TITLE: 2025 MOUNTAIN AIRE
87" HOME THEATER

DWG. NO. VI7000657 | REV. E

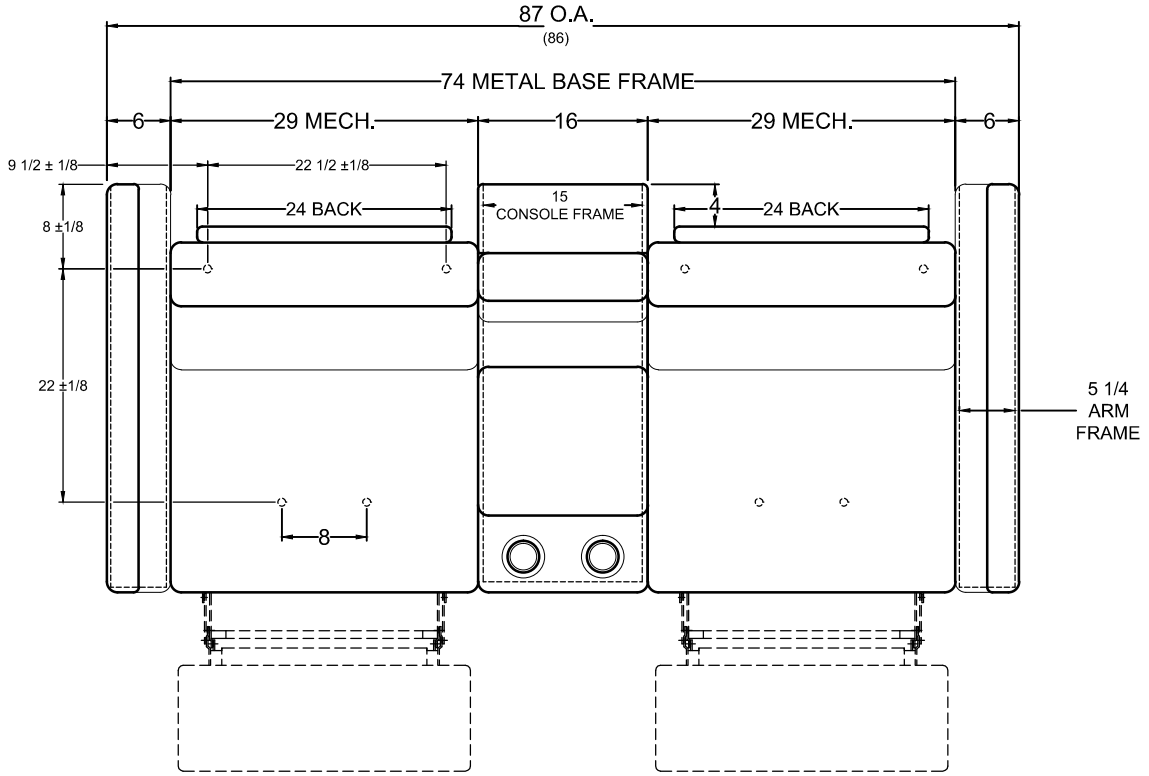
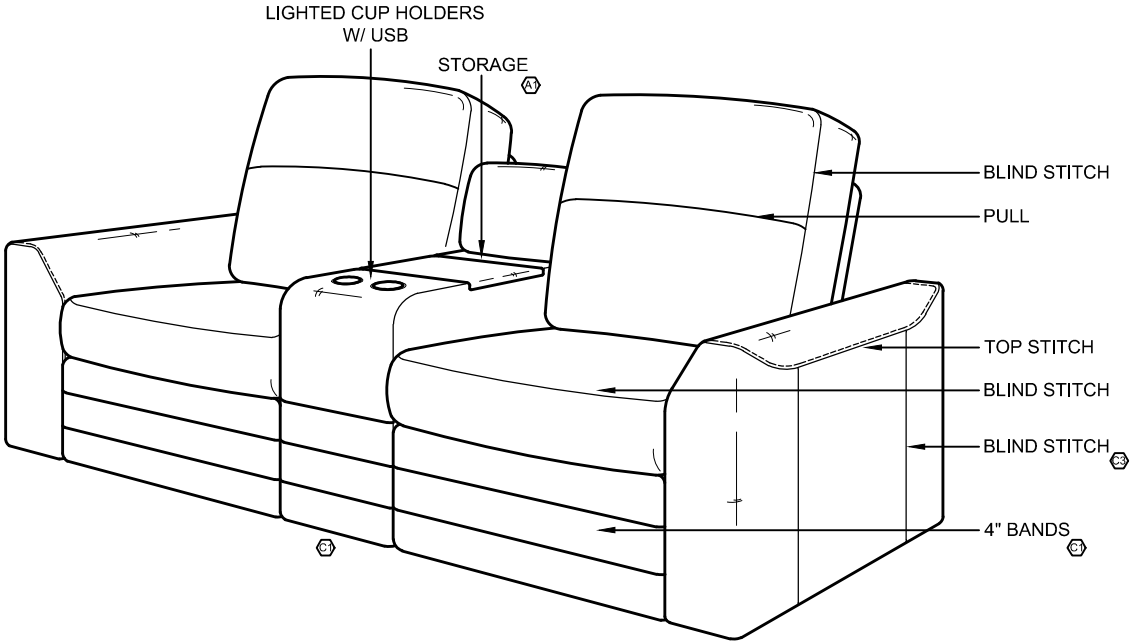
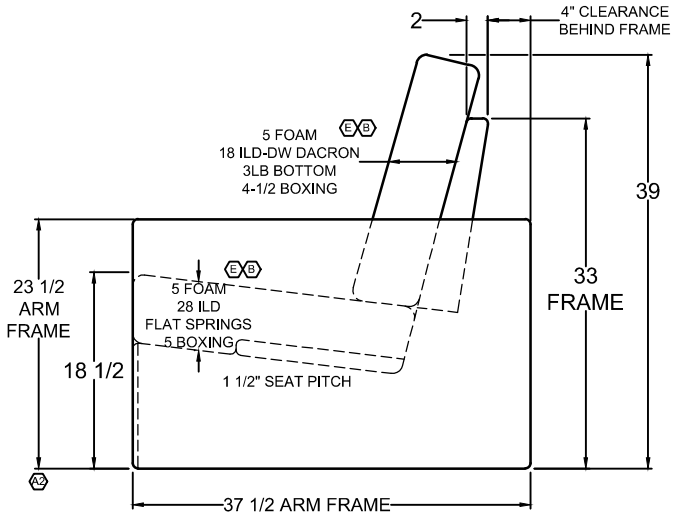
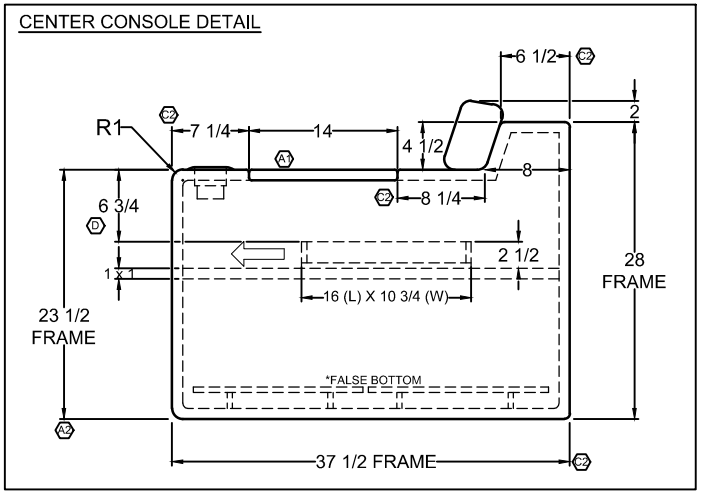
JA	E	PER LP, ADD 4-1/2" BOXING TO BACK PILLOW AND 5" BOXING TO SEAT CUSHION.	05.29.24
JA	D	PER RL, CORRECT CONSOLE SHELF HEIGHT TO 6-3/4"; WAS 4-3/4".	02.21.24
JA	C	[1] PER RL, CHANGE KICKBOARD BANDS TO 3 BANDS AT 4"; WAS 4 BANDS AT 3". ALSO INCLUDE BANDS ON CONSOLE. [2] ADD ADDITIONAL CONSOLE WOOD DIMENSIONS. [3] PER LP, ADD BLIND STITCHES TO SIDE OF ARMS.	10.24.23
JA	B	PRODUCTION UPDATE: REVISE FOAM DETAILS FOR SEAT AND BACK CUSHIONS.	07.20.23
JA	A	PRODUCTION UPDATE: [1] CHANGE CONSOLE TO HAVE FLUSH LID STORAGE TOP. [2] CHANGE CONSOLE & ARM FRAME HEIGHTS TO 23-1/2"; WAS 21-1/2".	06.21.23
